ICC A117.1 Comments on 2nd Draft

Proposal list to the 2017 A117.1 for the 2023 edition –
 03-30-2025
 Chapter 7 to 11

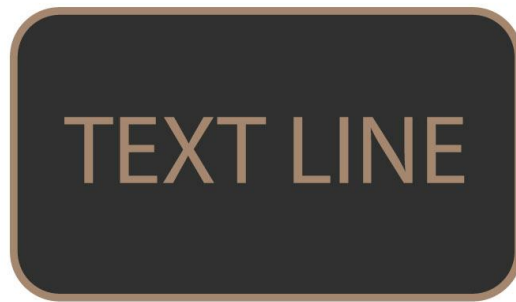
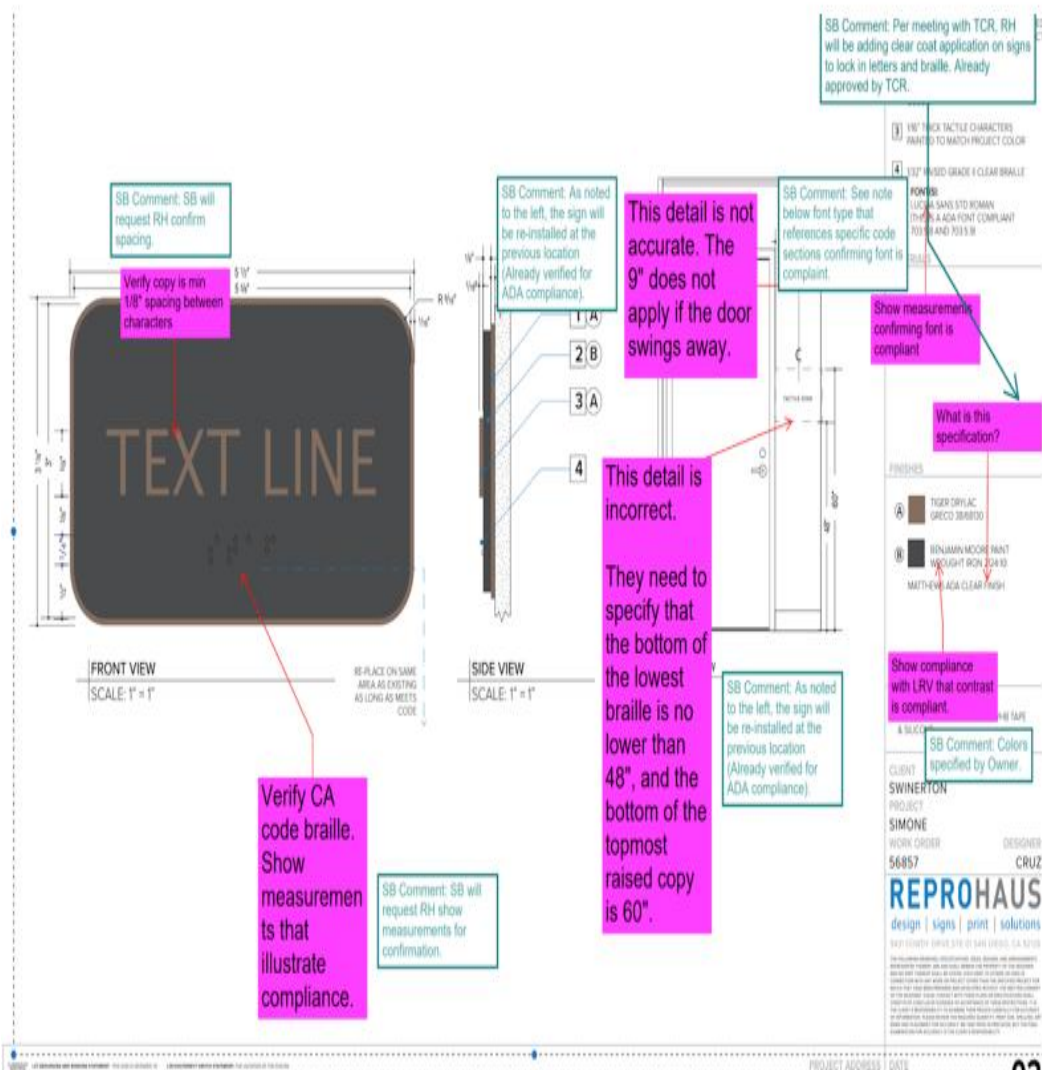
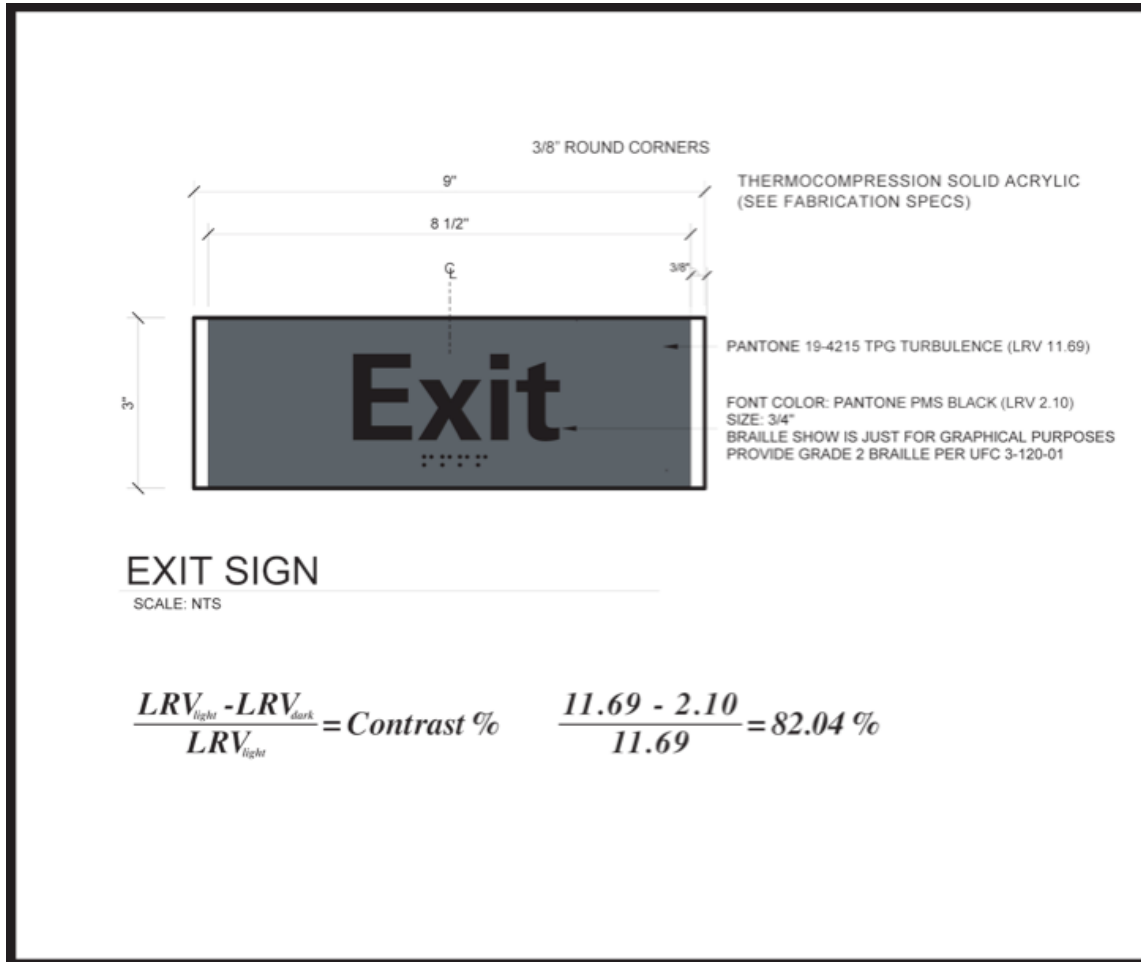
The Weber formula can optimize contrast for people having low vision, as well as people who have reduced contrast sensitivity only if it is qualified by a minimum LRV for the lighter surface. The following figures show how the Weber contrast (without qualification) can readily be 65% or greater when signs are comprised of two relatively dark colors, and not appear to the human eye as having high contrast. Black Magic on Green Herb, and Iced Mocha on Black Magic both contrast by more than 80%, well above the required 65%. Nonetheless, they are not perceived as having high contrast.

Signs meeting 65% (“Weber) contrast, that are nonetheless hard to read, are being designed and ordered. Here is an example of signage specifications that includes questions by the inspector in magenta. The lighter color is Tiger Drylac Greco 38/68130, which might be described as chocolate brown, and the darker color is black, Benjamin Moore Paint Wrought Iron 2124-10. The inspector asks for documentation of compliance with contrast, but does not specify what the contrast should be. The sign appears to be a (Weber) contrast much greater than 65%, yet the sign does not appear to be high in contrast, and it would be minimally legible in low illumination.

Here is another example of sign specifications, in which the LRV of the gray lighter color is 11.69, and the LVR of the black is 2.10. The resulting (Weber) contrast is 82.4%, far greater than the 65%; nonetheless the sign is not highly legible. Ironically, the designer is requesting exit signs, whose legibility may often be reduced by smoke, that are minimally legible.

Without qualifying the (Weber) contrast requirement of 65%, we are making it very simple for designers and manufacturers to design and manufacture signs that are minimally legible. We have not succeeded in creating a standard that will consistently result in signs that are legible to people with low vision, or to people with reduced contrast sensitivity. We have simply made it easy for designers and manufacturers whose products might have been disapproved by inspectors, based on their own perception, using the unquantified, hence unmeasurable, “light on dark or dark on light,” to state that signs that are minimally legible have high numeric contrast and pass a requirement for 65% contrast.

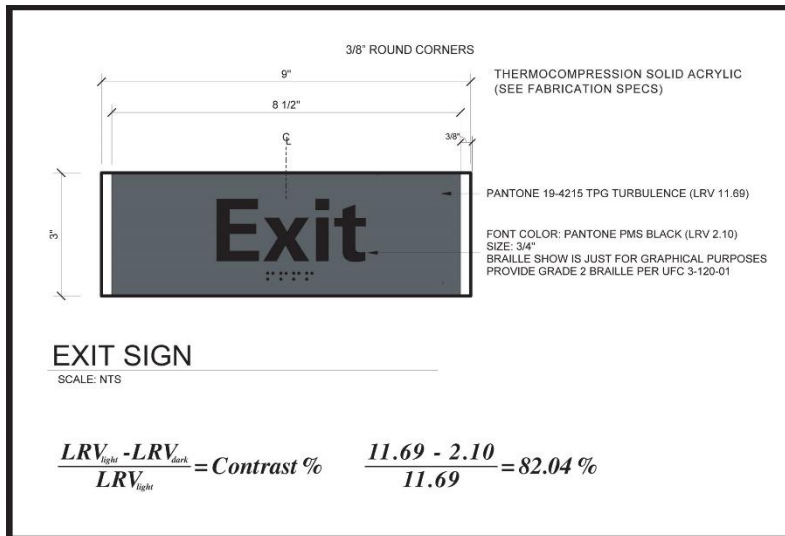
If the same sign designer is using Green Herb (LRV 27.8) as the darker color with Designer White (LRV 87.5), the contrast calculation also would be compliant with 68.23%.

$$\left[\frac{87.5 - 27.8}{87.5} \right] \times 100 = \left[\frac{59.7}{87.5} \right] \times 100 = [.6823] \times 100 = 68.23\% \text{ contrast}$$
